# UNITED STATES PATENT AND TRADEMARK OFFICE

10/574,340

<b>Office Action Summary</b>	<b>Application No.</b> 10/574,340	<b>Applicant(s)</b> COOK, PAUL	
	<b>Examiner</b> Melody M. Burch	<b>Art Unit</b> 3657

## DETAILED ACTION

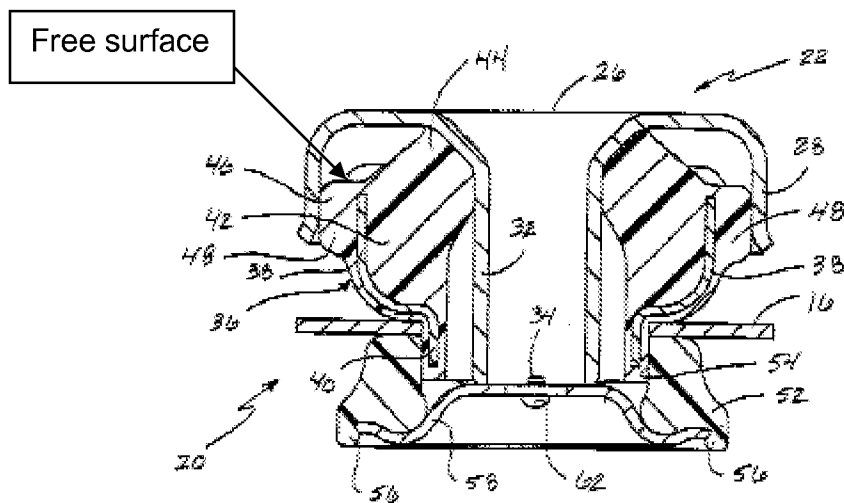
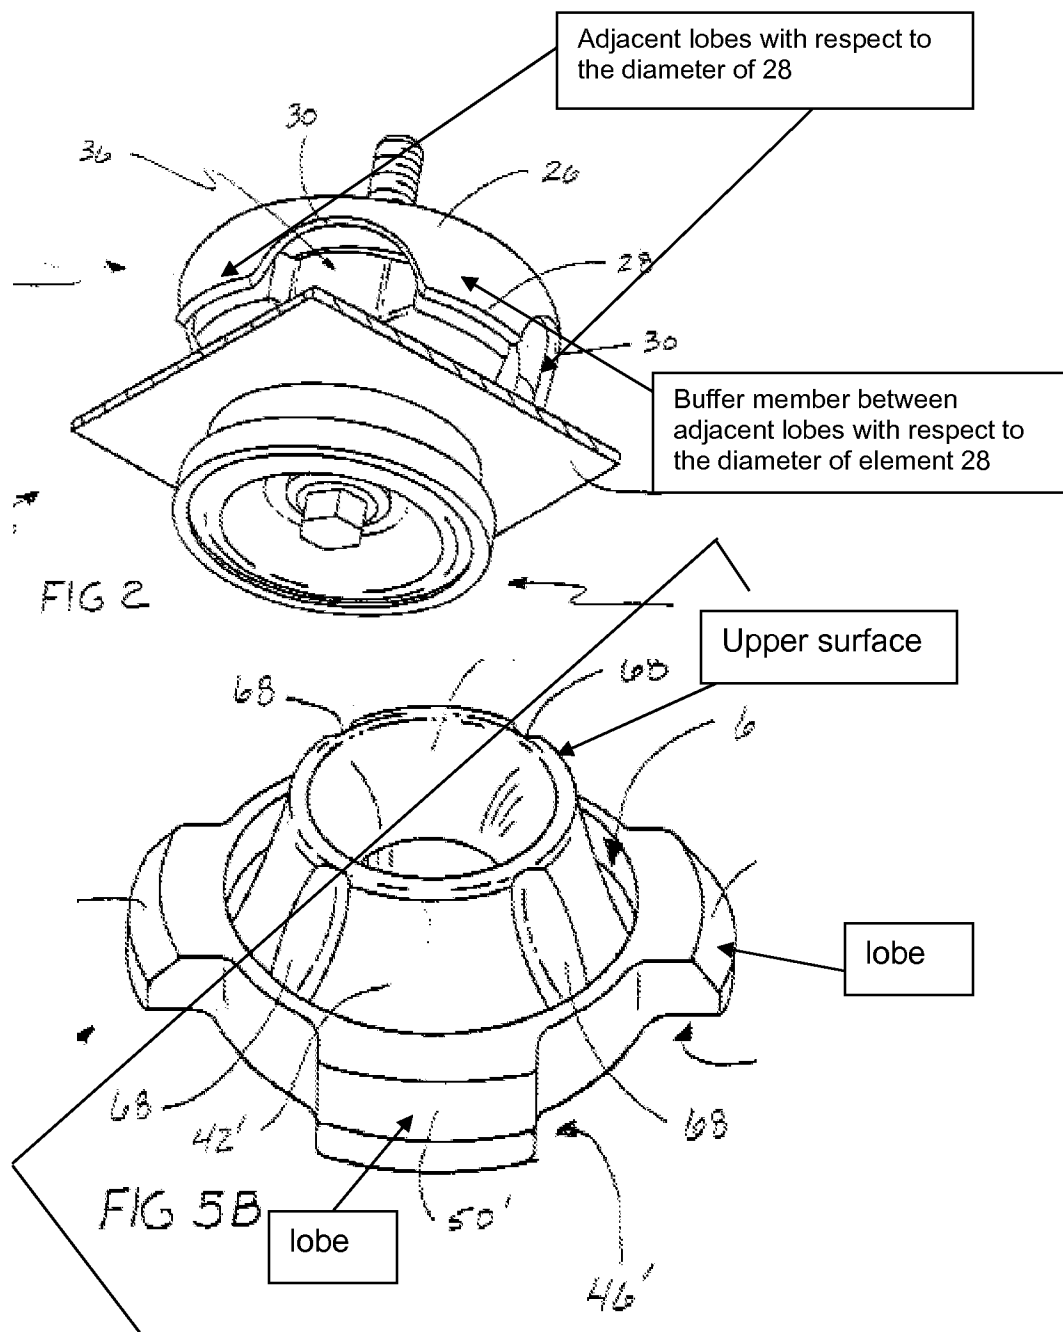
Re: claims 38-40. Rice et al. show in figures 1-3 and 4A a vibration mounting comprising a base member 16 for mounting to a mounting location and a support member 26 for supporting a load, the support member being spaced apart from the base member in a load-bearing direction by a vibration isolating element 36 of a resilient material, wherein the vibration isolating element comprises a plurality of lobes as labeled on pg. 6, 7 of this action each lobe extending from the base member towards

Re: claims 19, 20, 27, and 28. Rice et al. show in figures 1-3 a vibration mounting comprising a base member 16 for mounting to a mounting location and a support member 26 for supporting a load, the vibration mounting having a centre-line in said load-bearing direction; wherein the support member is spaced apart from the base member in a load-bearing direction by a vibration isolating element of a resilient material, which comprises a plurality of lobes as labeled on pg. 6, 7 of the action in figure 5B on each side of a plane passing through said centre-line, wherein each lobe

extends outwardly from a central portion of the vibration isolating element secured to the base member towards the support member and also extends in a lateral direction different from that of other lobes, and wherein each lobe has an upper surface as labeled on pg. 6 engaging the support member and at least one free surface as labeled on pg. 6, 7

And wherein the vibration mounting comprises a buffer means including a buffer member shown at the end of the lead line of number 28 shown in figure 4A extending

10. Applicant's arguments filed 2/3/09 have been fully considered but they are not persuasive. Applicant argues that Rice et al. fail to disclose a buffer member that is between adjacent lobes. Examiner disagrees and notes that on pg. 7 of the Office action Rice et al. illustrates a buffer member that is between adjacent lobes. Nothing in the claim language precludes adjacent lobes from meaning lobes situated across from each other as opposed to lobes situated circumferentially by each other. Applicant then argues that Rice et al. lack the limitation of the first and second buffer members, explaining that the cushions are always in contact with their rigid neighbors. Examiner disagrees and notes that the claim language simply requires buffer members or means and does not require that the buffer members or means comprise a gap between cushions as Applicant argues. The argument is more specific than the claim language. Examiner maintains that the limitation of increasing resistance to displacement beyond a displacement threshold is satisfied in Rice et al. by having multi-stage displacement/resistance as set forth in the rejections above similar to that of the instant invention except the gaps in Rice et al. are filled with elastomeric material. Accordingly, the rejections using the Rice et al. reference have been maintained.
